Group 7 Steering

FMC Corporation
Recreational Vehicle Division
333 Brokaw Road Box 664 Santa Clara, California 95052

<p>ATTENTION: SERVICE MANAGERS</p>	<p>GROUP</p>						
<p><u>DESCRIPTION</u></p>	<p>SUBJECT</p>						
<p>This bulletin provides instructions for replacement of the present pitman arm on the FMC 2900R motor coach.</p> <p><u>COMPLIANCE</u></p> <p>Dealers must comply with this bulletin prior to delivery of coach to owner. Present owners must return coach to dealer for this modification in accordance with recall notification number A0702, dated 17 December 1973.</p>	<p>REPLACEMENT OF PITMAN ARM</p>						
<p><u>MANPOWER</u></p> <p>Estimated accomplishment time for one mechanic is approximately two hours.</p> <p><u>MATERIAL</u></p> <p>Parts supplied at no charge by FMC-RVD are:</p> <table border="1" data-bbox="243 1081 1201 1197"> <thead> <tr> <th>TITLE</th> <th>RVD P/N</th> <th>QTY PER COACH</th> </tr> </thead> <tbody> <tr> <td>Pitman Arm</td> <td>5106072</td> <td>1</td> </tr> </tbody> </table>	TITLE	RVD P/N	QTY PER COACH	Pitman Arm	5106072	1	<p>MODEL(S) AFFECTED</p> <p>2900R</p> <p>(Factory Use Only) Information added to:</p>
TITLE	RVD P/N	QTY PER COACH					
Pitman Arm

FIGURE 1. STEERING GEAR REINFORCEMENT KIT INSTALLATION

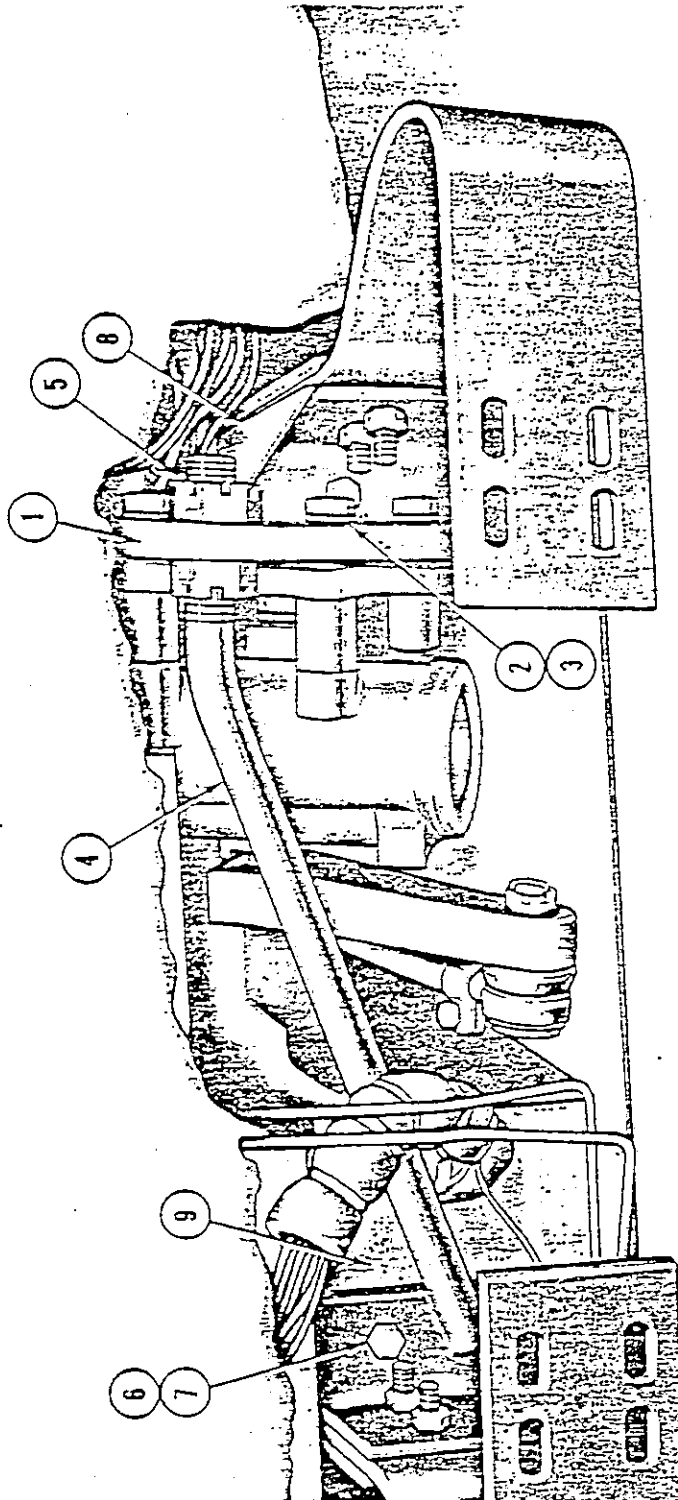
ATTENTION: SERVICE MANAGER	GROUP
<u>ACCOMPLISHMENT INSTRUCTIONS (continued)</u>	7
<p>floor underneath coach in a general pattern resembling the installed configuration, to facilitate rapid location of reused attaching hardware during reinstallation. Proceed as follows:</p> <p>(1) Remove the nuts, washers and bolts attaching the front bumper to the two, bumper mount, leaf springs located on LH side of coach; do not remove bumper.</p>	SUBJECT
<p>(2) Remove locknuts and bolts attaching the two LH inboard and outboard bumper leaf springs to the four frame mount brackets; remove springs and retain. Retain attaching nuts and bolts.</p> <p>(3) Remove the frame mount bracket, nearest to coach centerline, of the inboard mount bracket set, by removing lock nut and attachment bolts, Retain bracket locknuts and bolts. Repeat removal procedure for adjacent bracket, but discard nuts and bolts and retain bracket only.</p>	MODEL(S) AFFECTED

<u>NOTE</u>	
<p>To provide better access to the top bolt for the next step and for installing new parts, the lower corner edges of the panel and the aluminum angle in the vicinity of work area, may be bent back about 50 degrees, using vise grip pliers or similiar tool. Temporarily tie-back or tape all wiring back away from bracket mount areas during these procedures.</p>	
<p>(4) Repeat step (3) for the outboard bumper spring-leaf-to-frame attach bracket set but retain all attaching locknuts and bolts; discard only the two brackets.</p>	
<p>(5) Remove the three bolts and lockwashers attaching the steering gearbox to the mount bracket; discard bolts and washers.</p>	
<p>D. See figure 1 and install the reinforcement kit components and the parts retained during disassembly, in the following sequence:</p>

POWER STEERING PUMP CAP

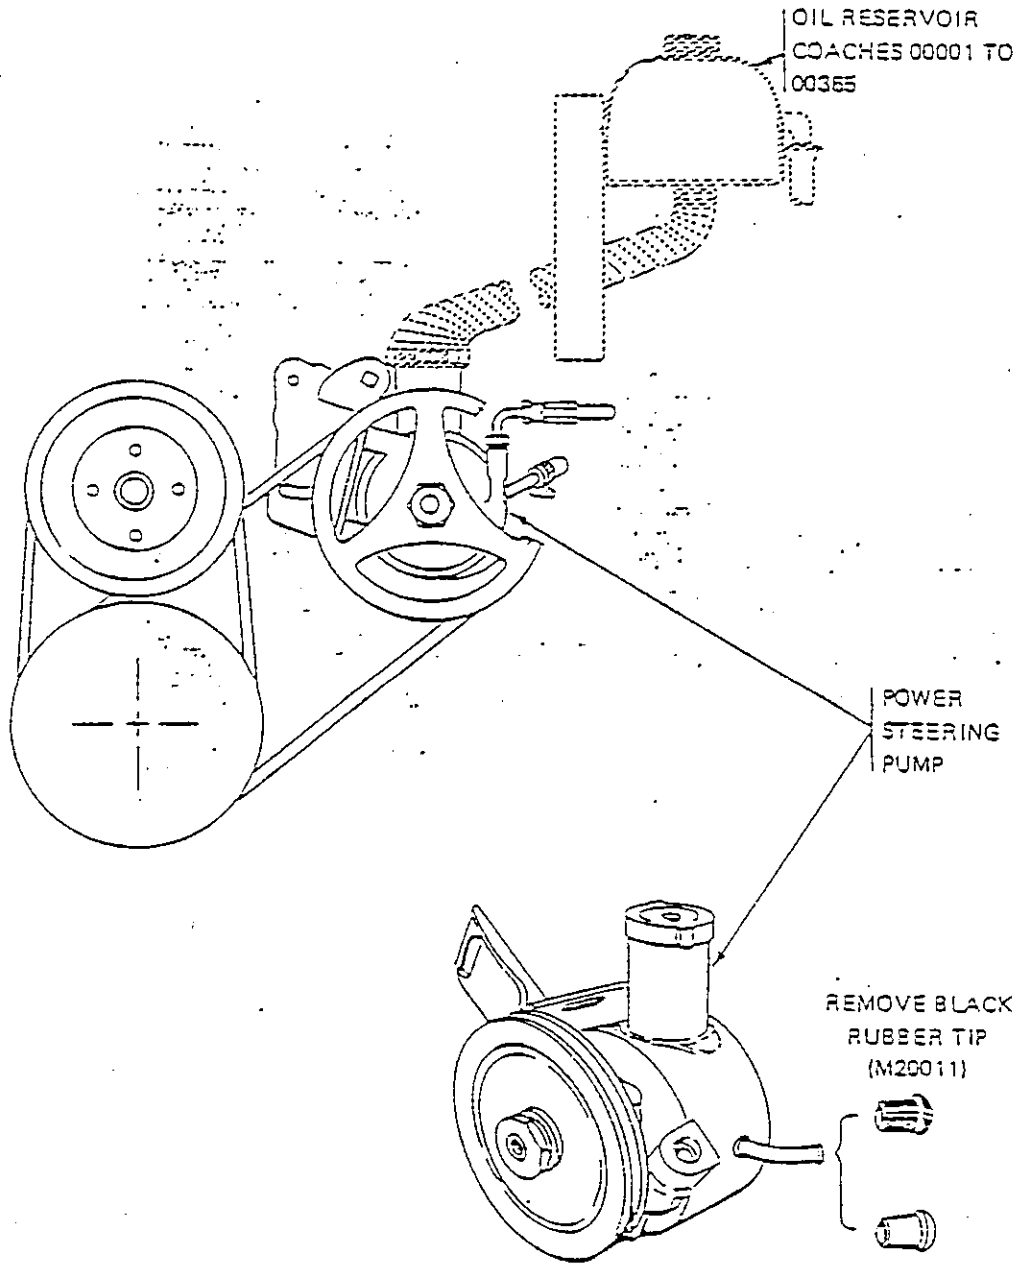
<p>ATTENTION: SERVICE MANAGERS AND OWNERS</p>	<p>GROUP</p>
<p>On motor homes that fall within the serial range of 00001 to 00365, a black rubber cap was used on the power steering pump. Over a period of time, and with the accumulation of mileage on your coach, this black rubber cap could deteriorate and leak oil.</p> <p>Please check your coach and if you have a black rubber cap on the power steering pump, remove it and replace with the new grey rubber cap furnished with this bulletin. Use existing clamp to install new cap.</p> <p>See illustration for details and make the above change as soon as possible.</p> <p>Should there be a charge to you for installing the new cap, submit the bill to us and we will reimburse you, but only up to a maximum of \$3.00 per coach.</p>	<p>7 Motor Home</p> <p>SUBJECT</p> <p>Power Steering Pump Capped Outlet</p>
<p style="text-align: center;"> Dave Enget Service Manager</p>	<p>MODEL (S) AFFECTED</p> <p>Motor Homes Serial 00001 to 00365 approximately</p>

To correct this condition on your vehicle, you should perform the modification as described in the attached service bulletin #2907-10004. After the new parts have been installed, please complete and mail the enclosed pre-addressed post card. If you have sold or disposed of the subject vehicle, please note on the prepaid card so that we may adjust our records accordingly.

Figure 1. Steering linkage.

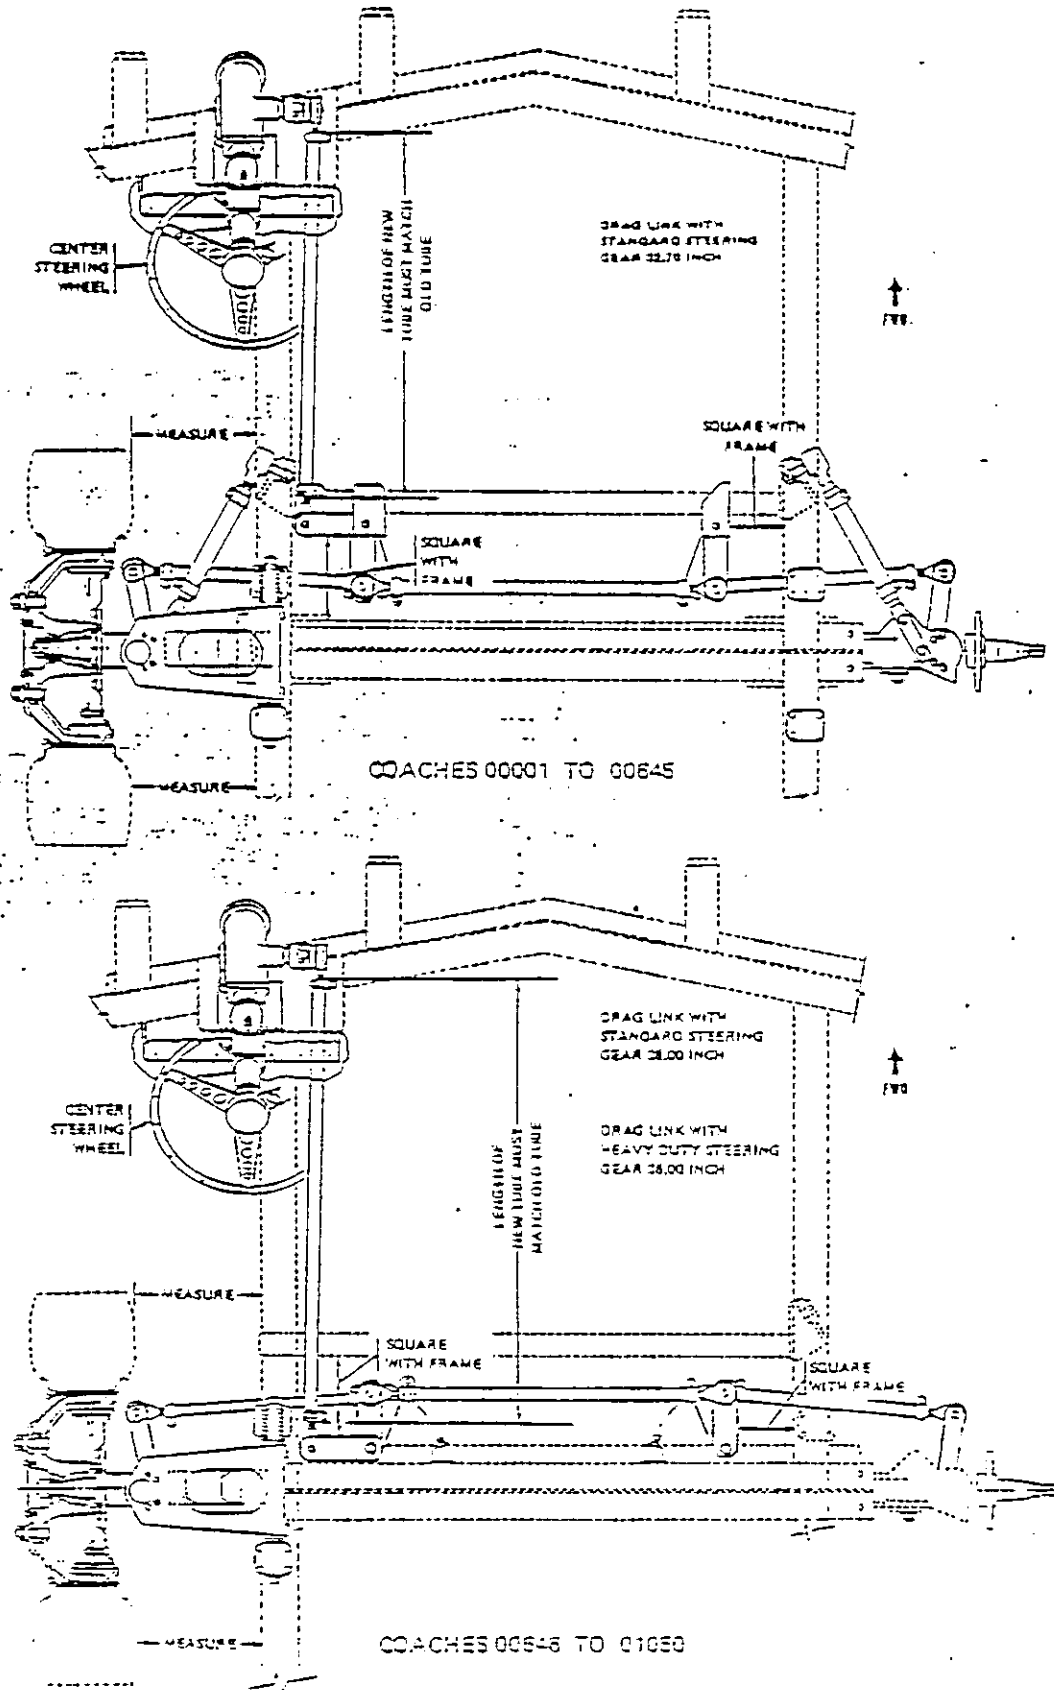
5. Saturate all tube clamps and tie rod ends with "WD40", "Liquid Wrench", or other suitable penetrating oil. Wait at least 10 minutes.	OTHER
6. Loosen clamps on cross link and remove cross link tube. Discard old tube. 7. Install new cross link tube, starting each end simultaneously, position clamps so that bolt faces downward, and tighten clamp bolts. NOTE: If coach serial number is 00646 or higher use existing clamps; if coach serial number is between 00001 and 00645 use new clamps (S100759).

<p>ATTENTION: SERVICE MANAGERS AND OWNERS</p>	<p>GROUP</p>
<p>It might be necessary to spread existing clamps before installing on new tube.</p> <p>8. Loosen clamps on control link tube and remove control link tube. Discard old tube.</p> <p>9. Install new control link tube, position clamps so that bolt faces downward, and tighten clamp bolts.</p> <p>10. Repeat steps 8 and 9 for control link on opposite side of vehicle. See note in step 7 regarding new clamps.</p>	<p>7</p> <p>SUBJECT</p>
<p>11. Loosen clamps on drag link tube and remove drag link tube. Discard old tube.</p> <p>12. Install new drag link tube, position clamps so that bolt faces downward, and tighten clamp bolts. See note 7 regarding new clamps.</p> <p>13. With steering wheel centered, check clearance between new drag link tube and hole in frame crossmember. You should have a minimum of 1/8 inch clearance between drag link and hole (Fig 2).</p>	<p>MODEL (S) AFFECTED</p>
